**ADDENDUM
NO. 4**

October 18, 2024

**Whiteland High School Ph 2: Café Kitchen Band Choir Auditorium
300 E. Main Street
Whiteland, IN 46184**

4 AUDITORIUM LOBBY TO LOWER ROOF DETAIL
SCALE: 1" = 1'-0"

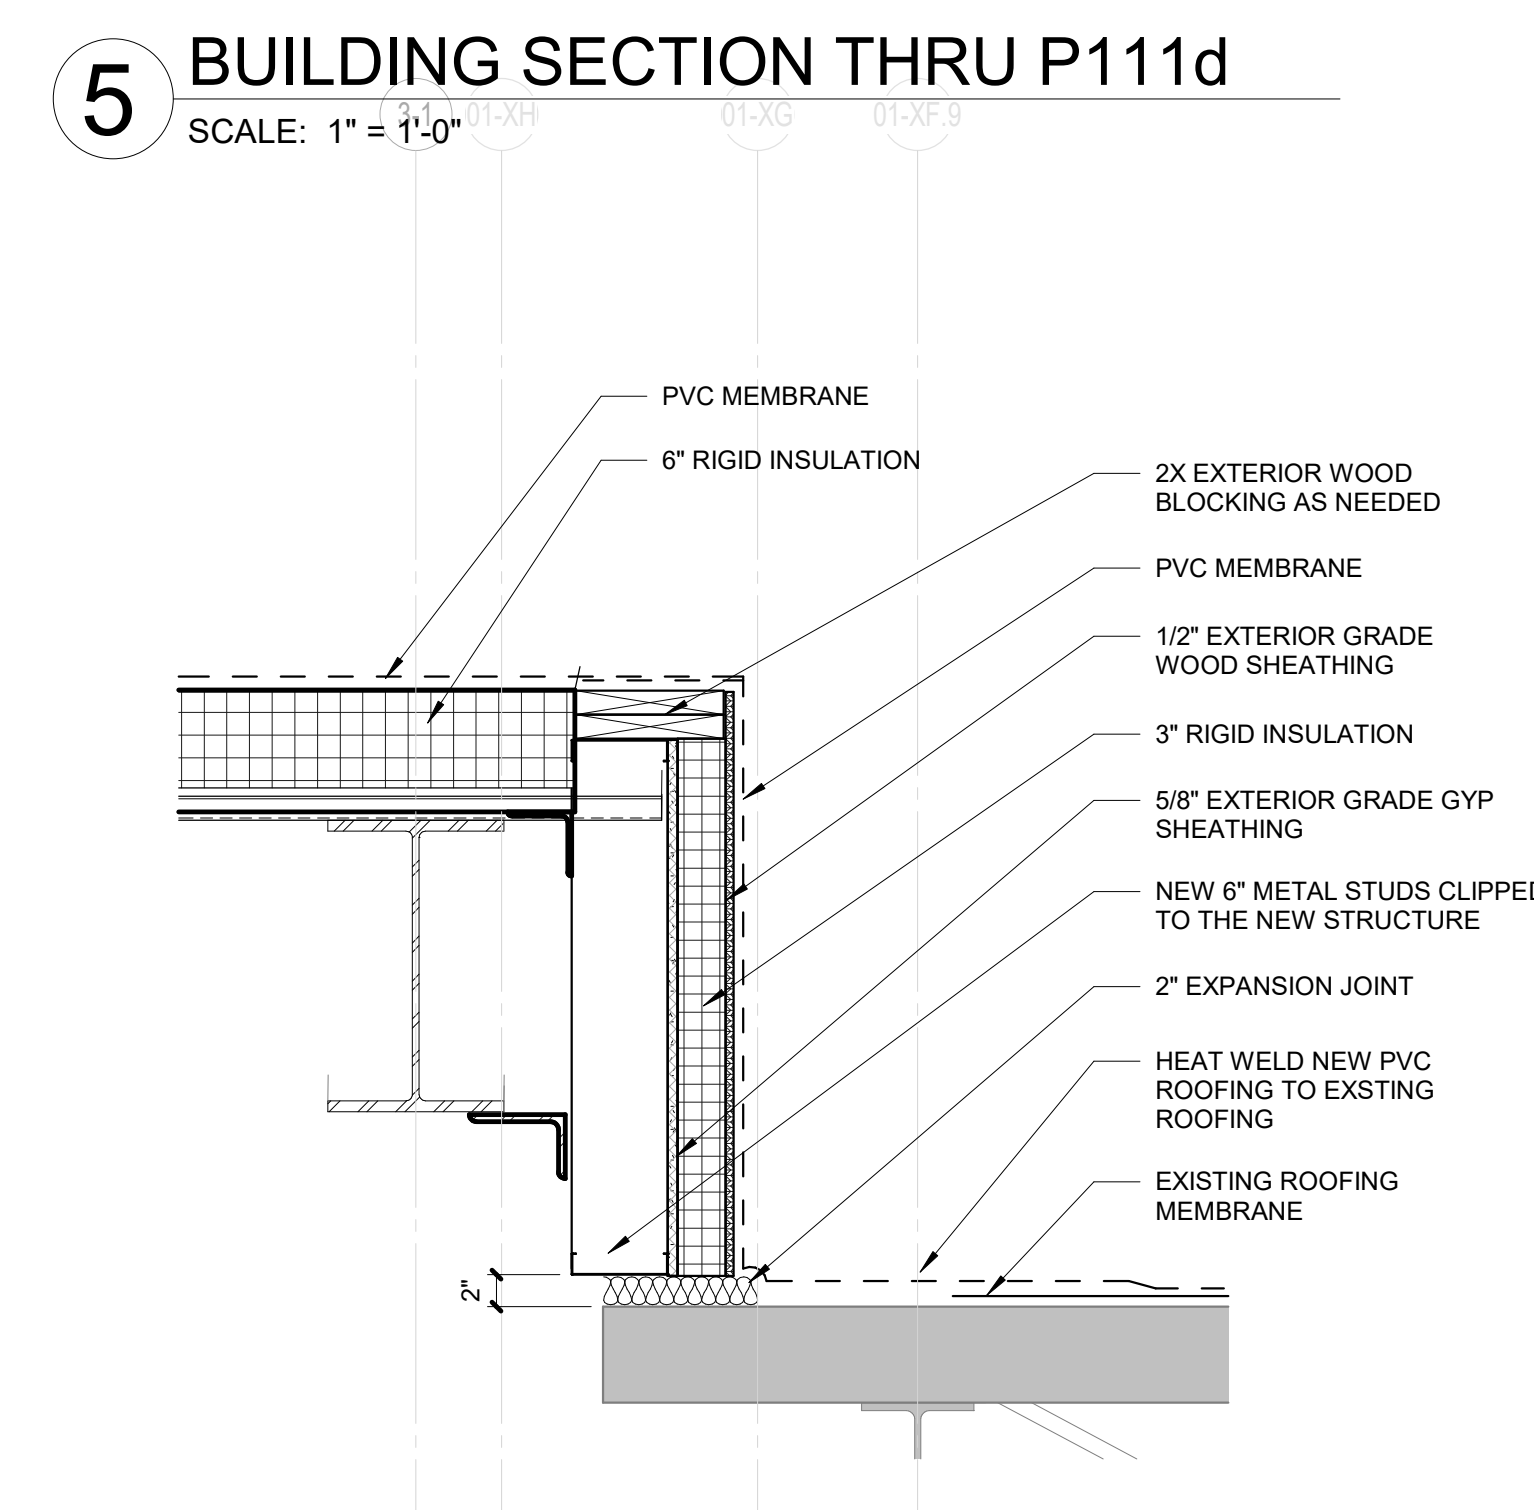
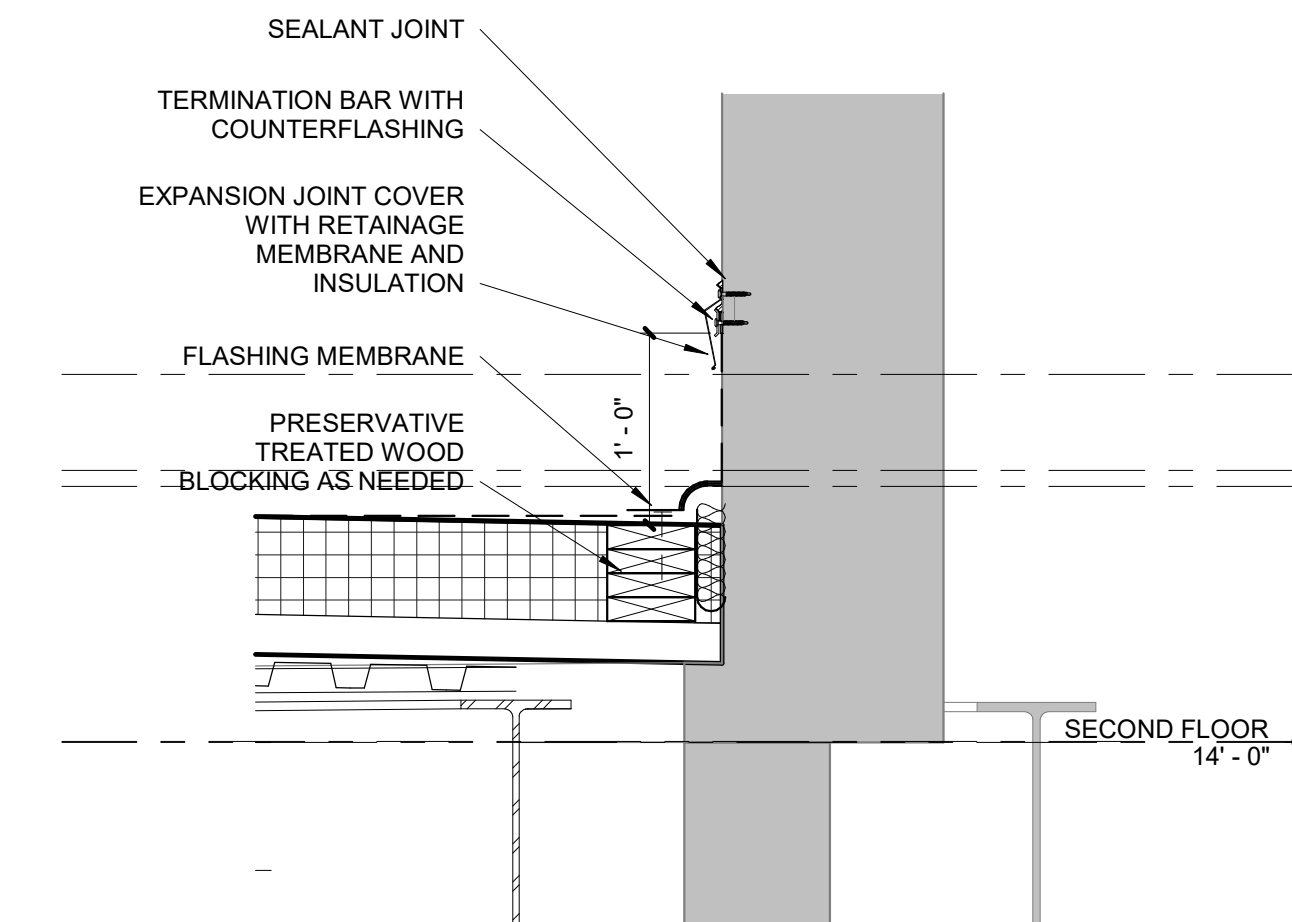
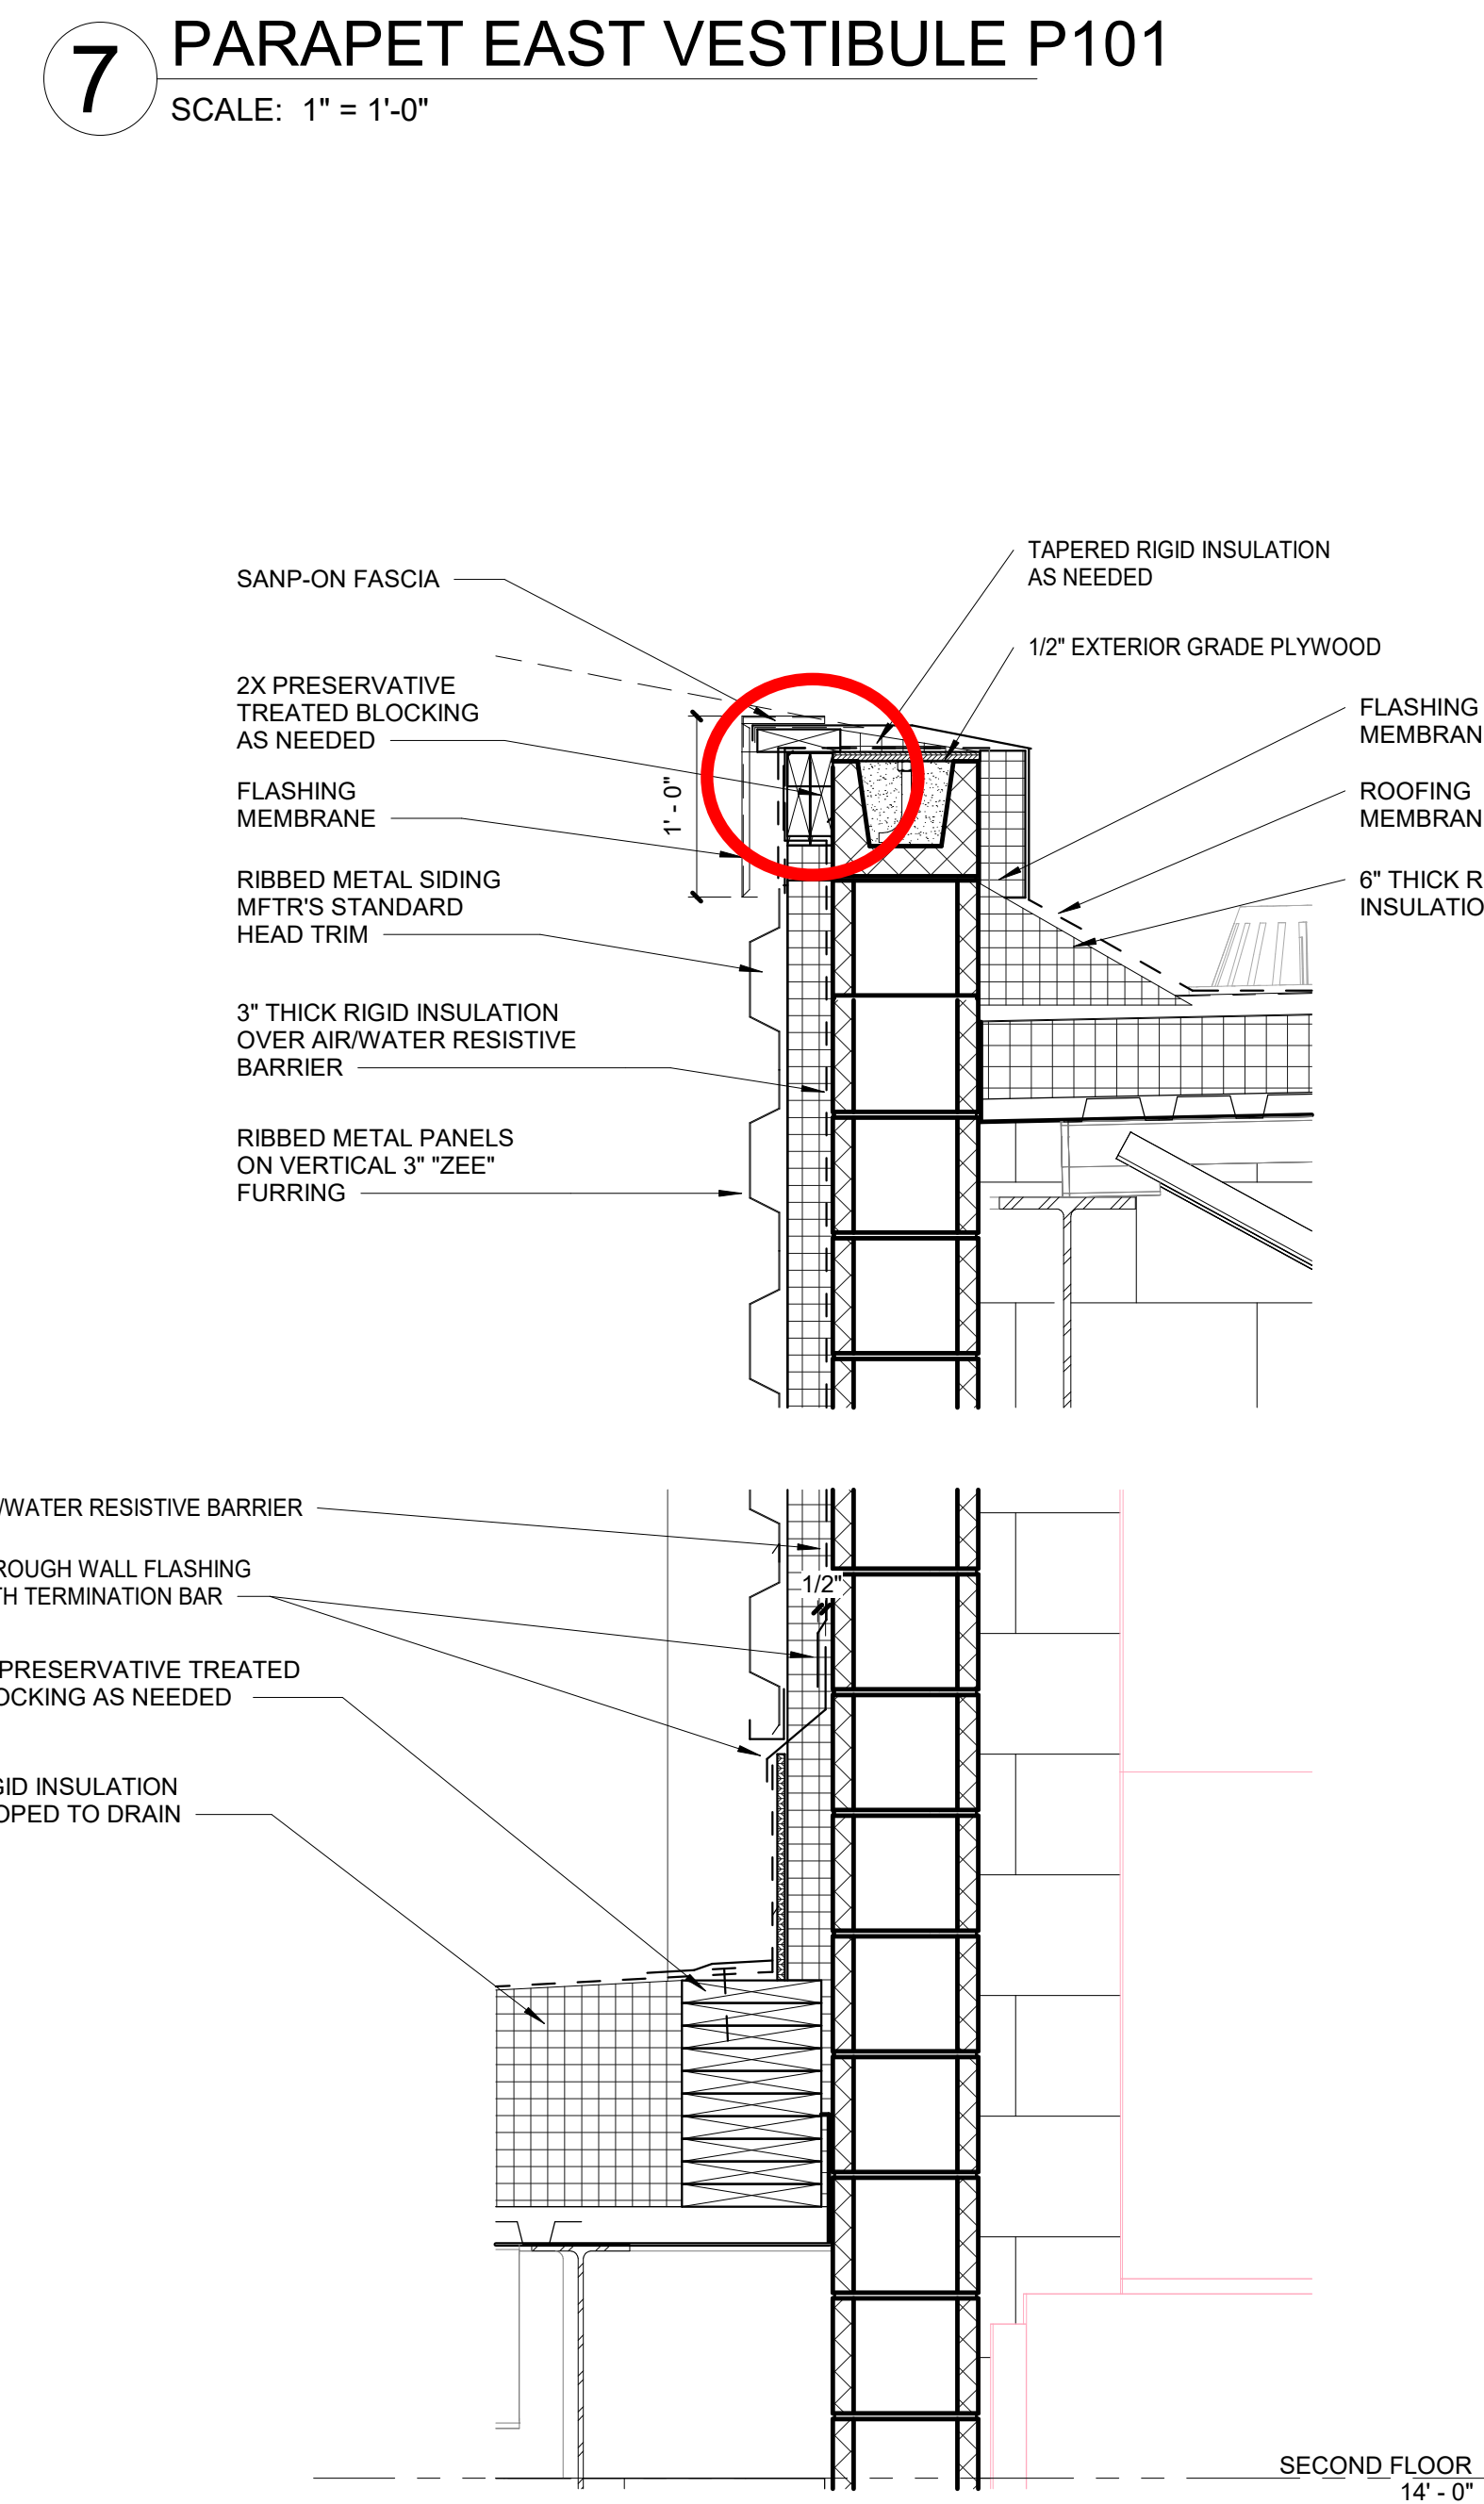
7. Bid Category No. 5 – Metal Studs, Drywall, and Acoustical Contractor is responsible for any board insulation behind metal panels that include Z-Girt installation.
8. Bid Category No. 5 – Metal Studs, Drywall, and Acoustical Contractor is responsible to provide and install all required wood blocking circled in red in the attached

all blocking in question and circled in red will be the responsibility of Bid Category No. 5 Contractor
